# **ADDENDUM**

## **Trackstar Board Installation for Tandy 1000 TX**

**Note:** This addendum is used only for Tandy 1000 TX users. Page 35 of the manual is replaced with this addendum for the Tandy 1000 TX.

## Modifying Trackstar Disk Adaptor Cable

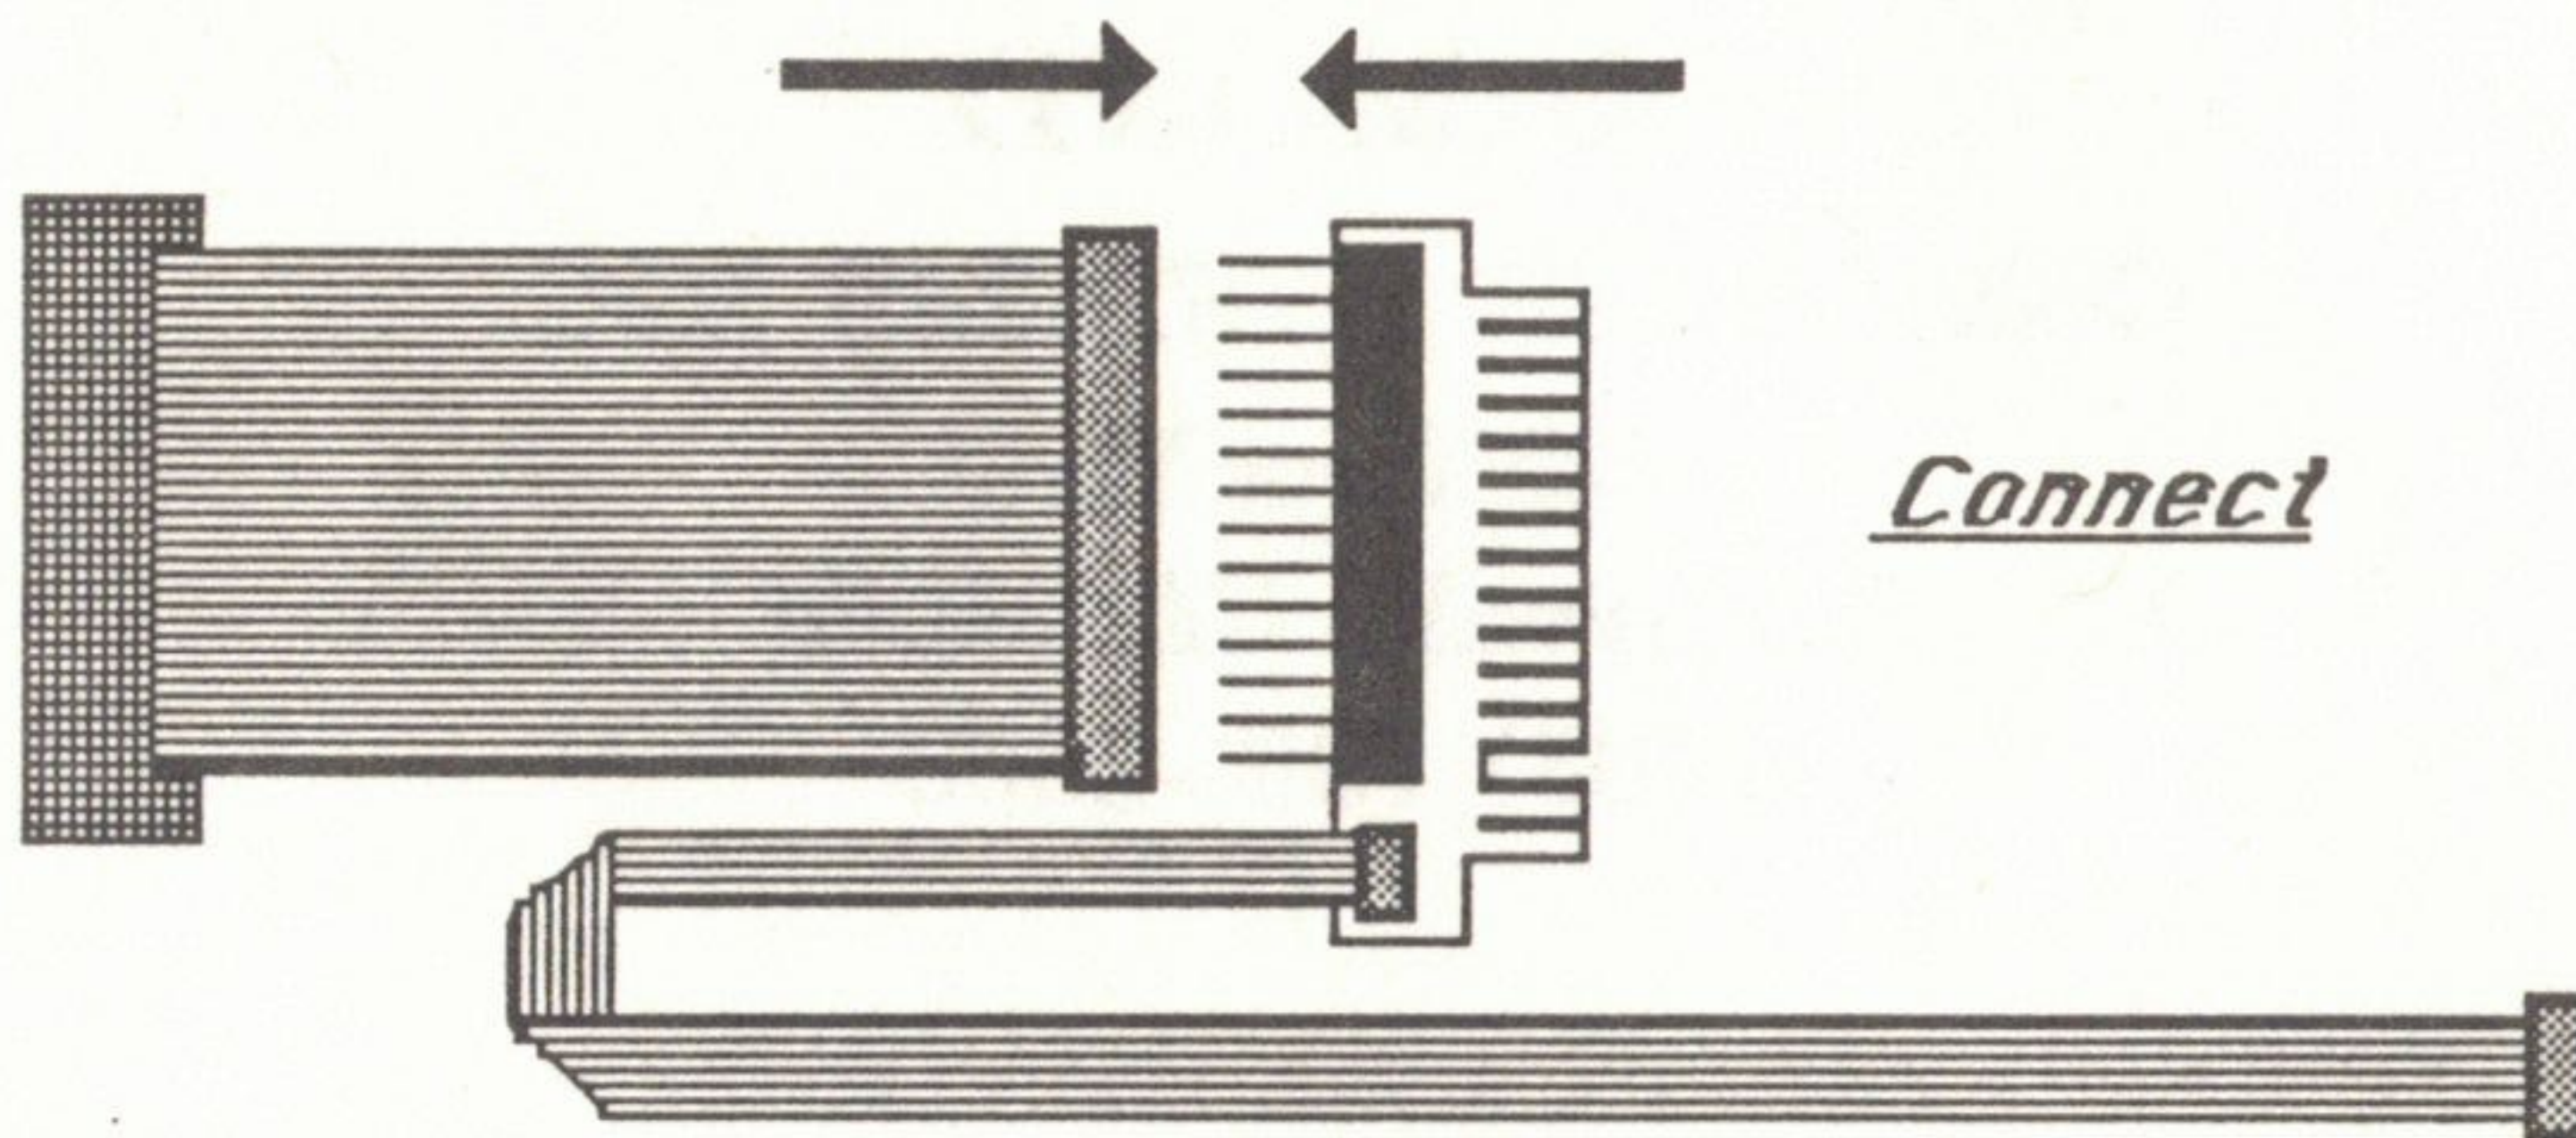
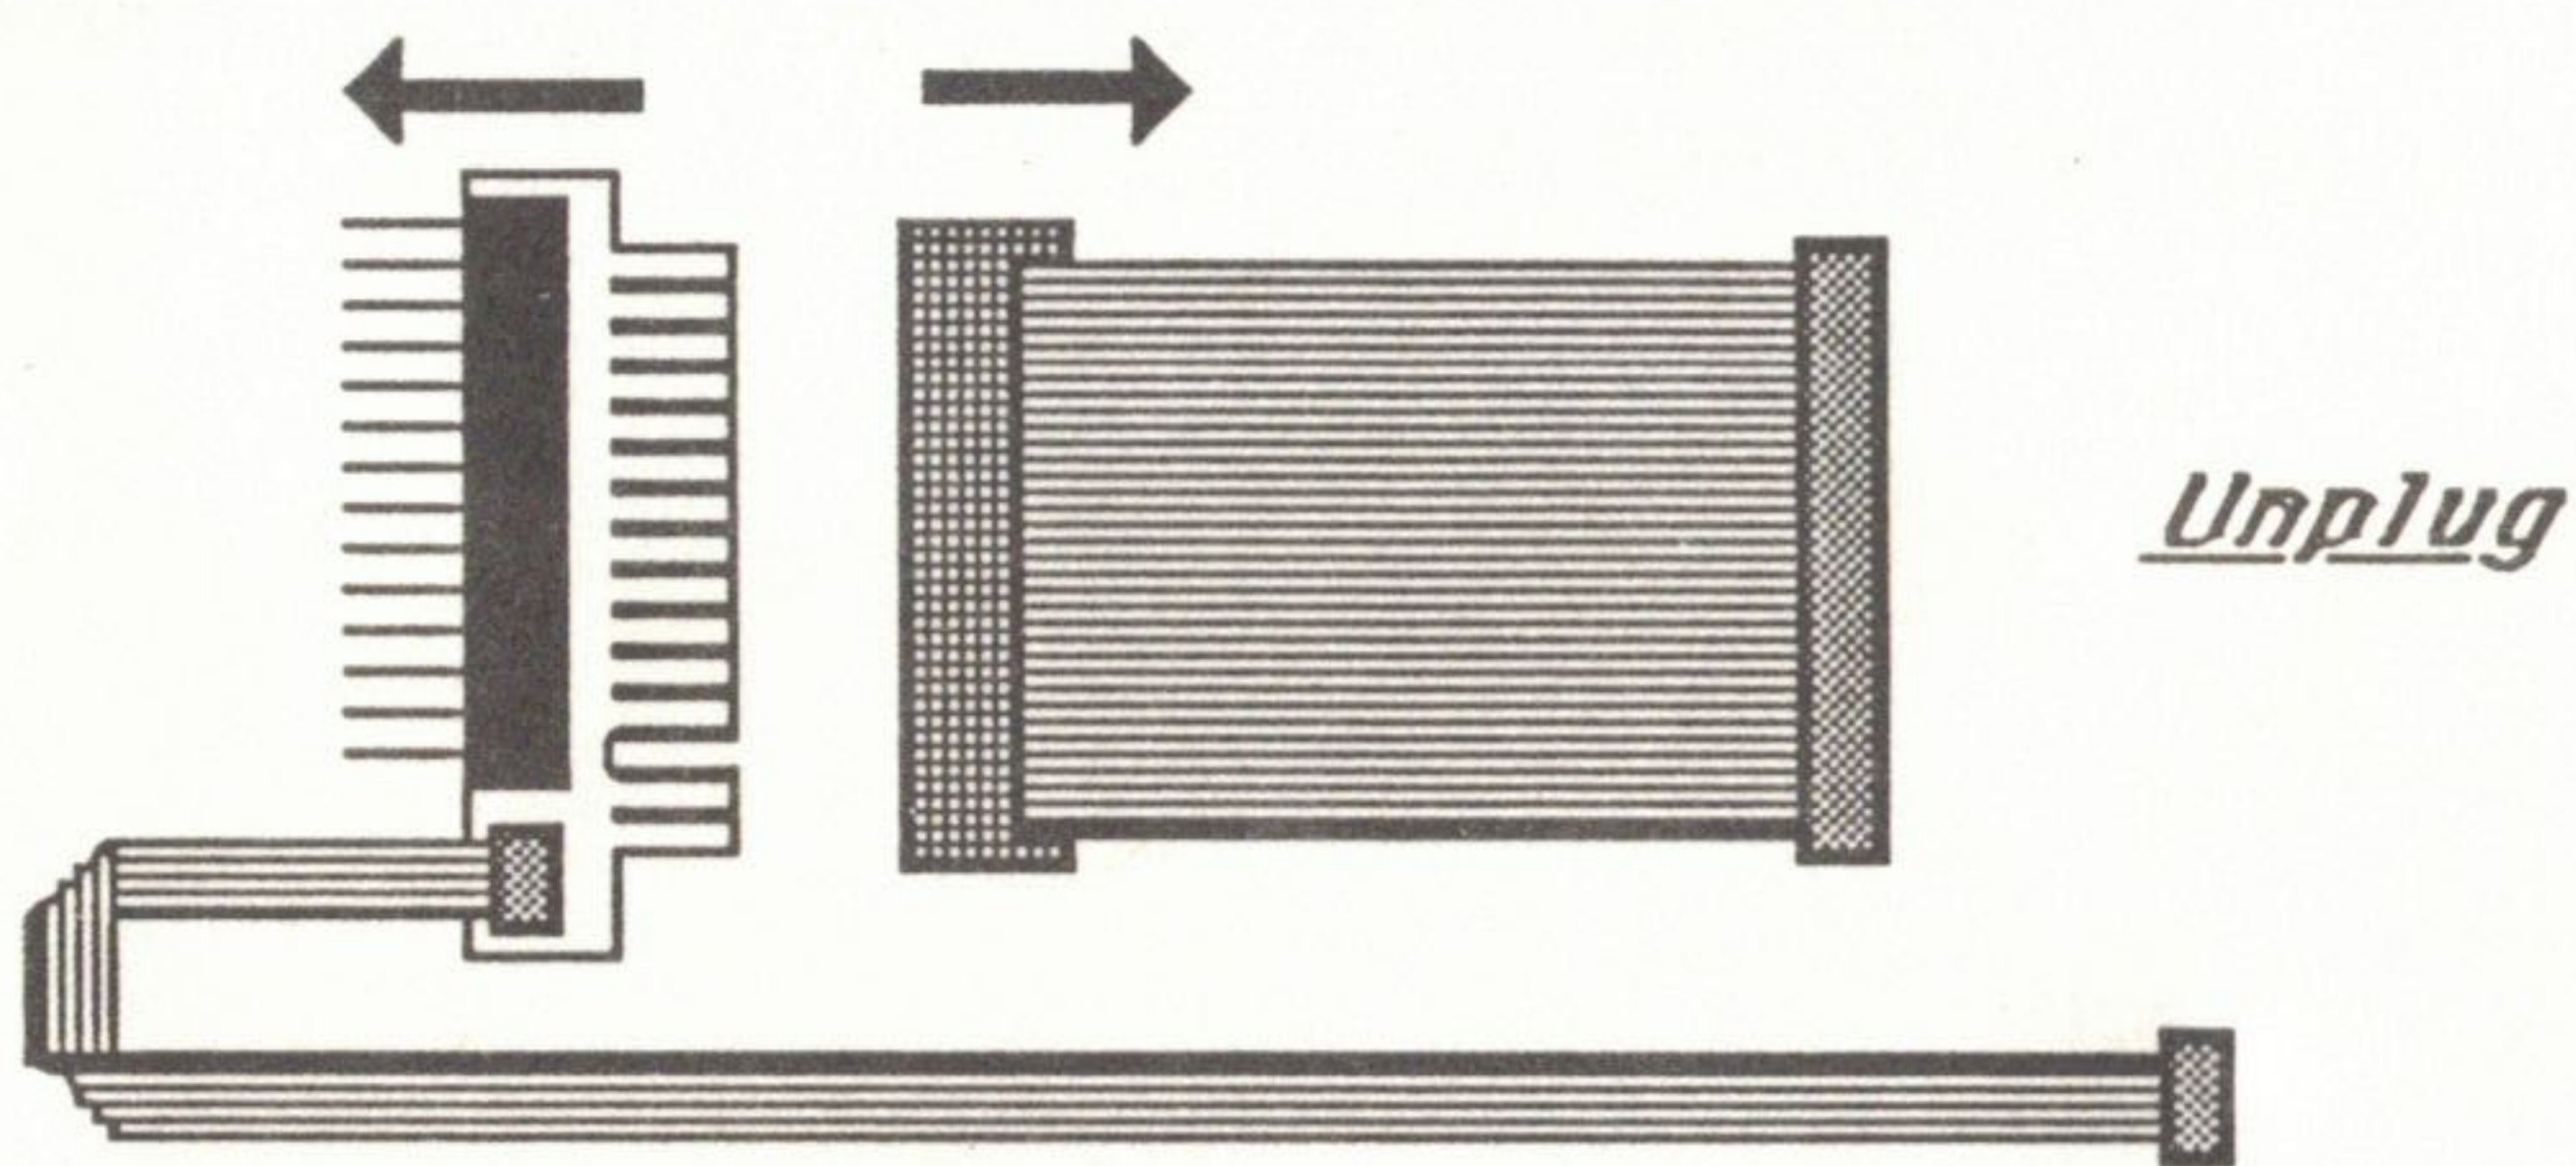
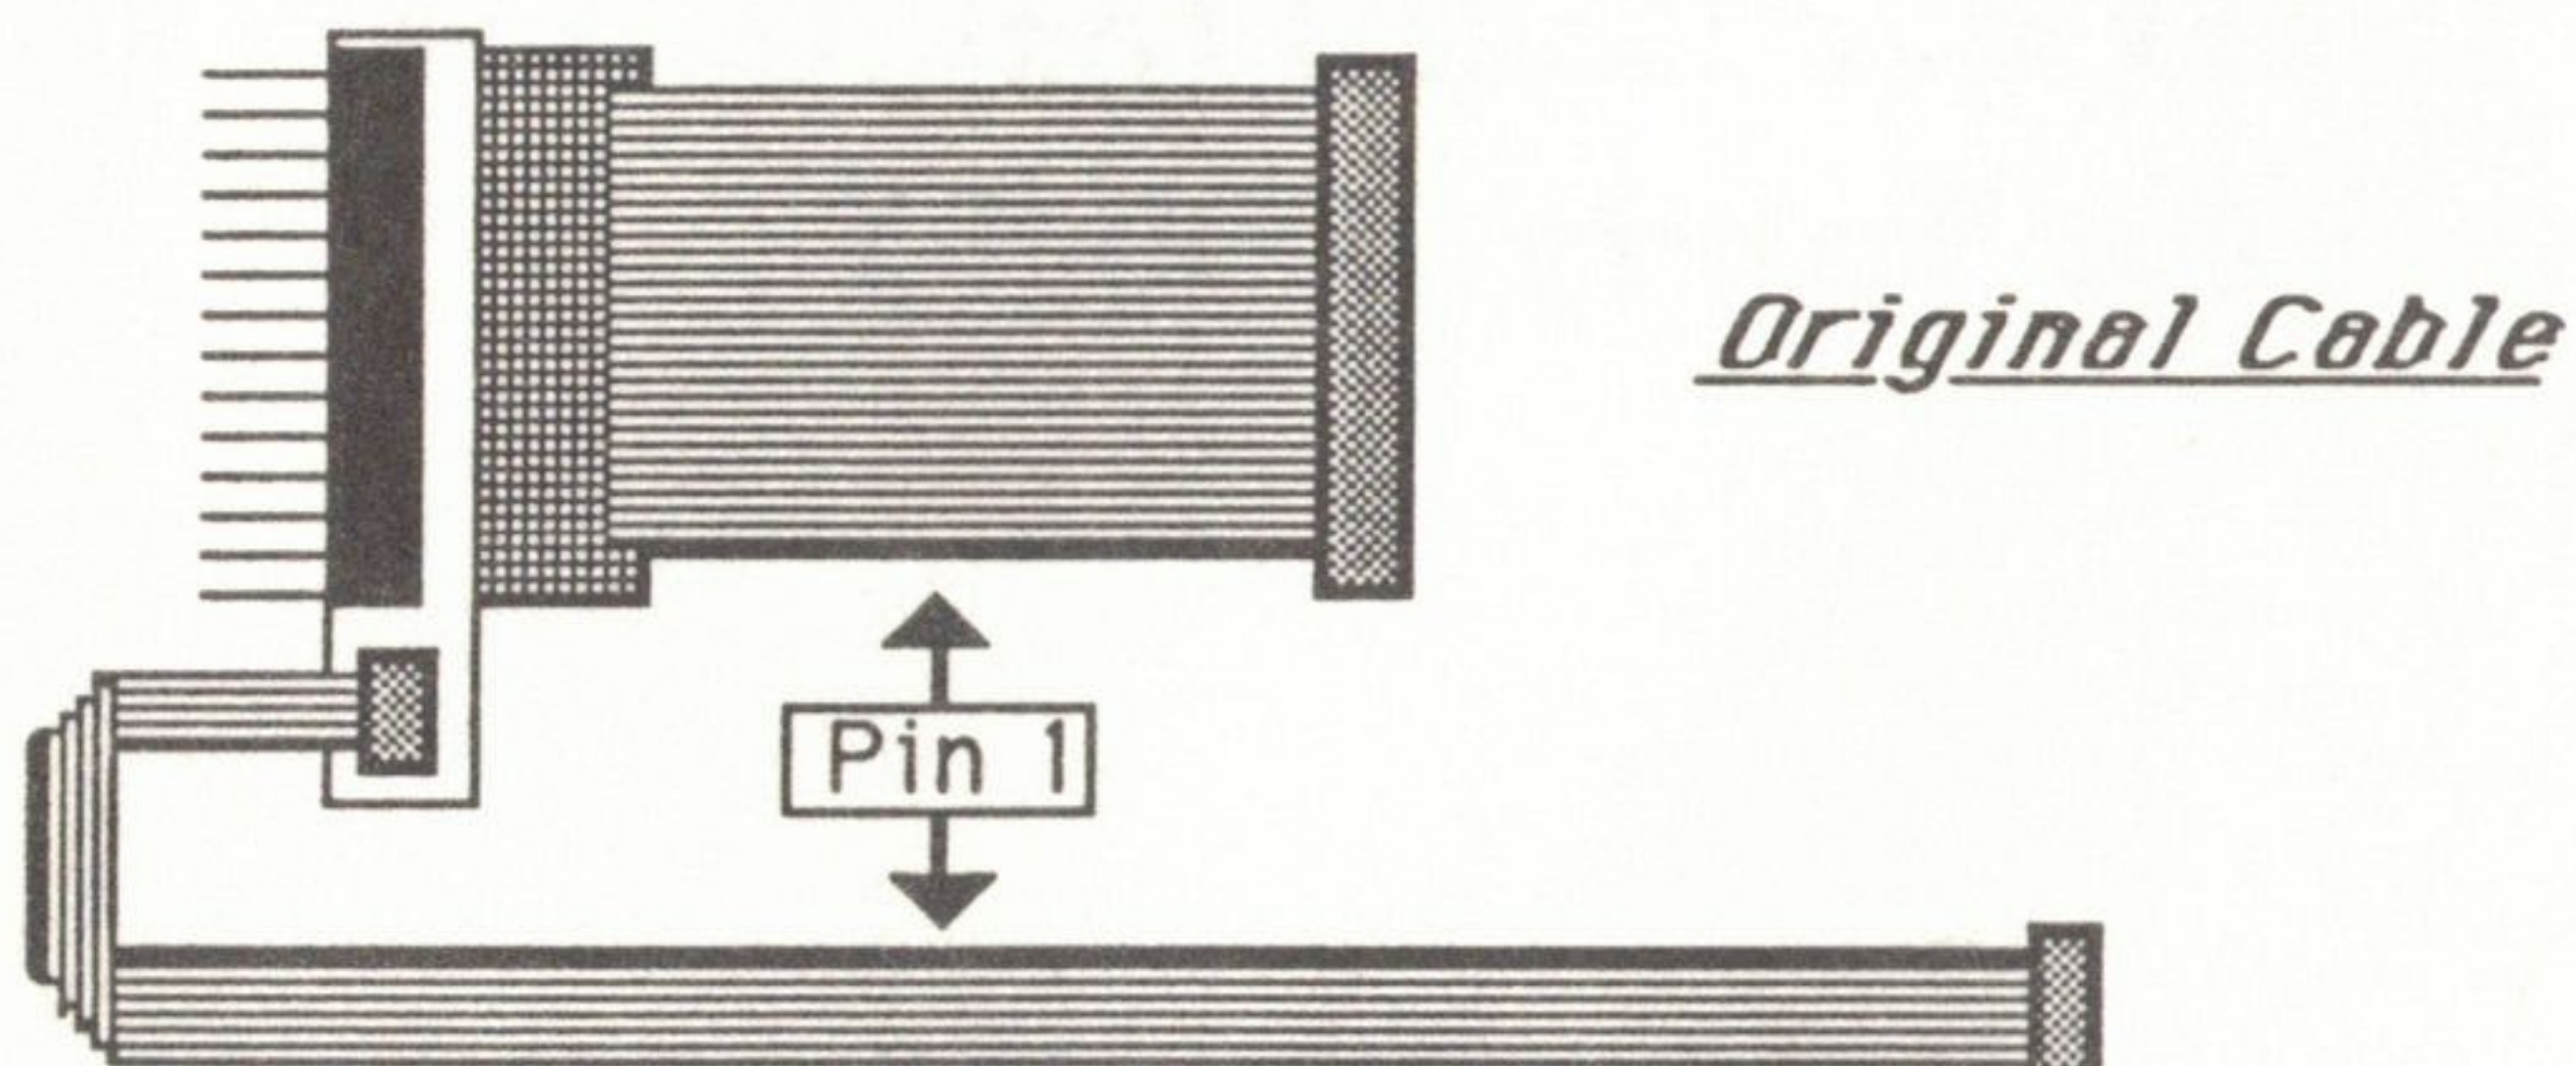
The disk drive adaptor cable should be modified to be used for the Tandy 1000TX computer as follows. The thick wires of the cables, which are colored wires, indicate "Pin 1" of the cables. "Pin 1" should match one another.
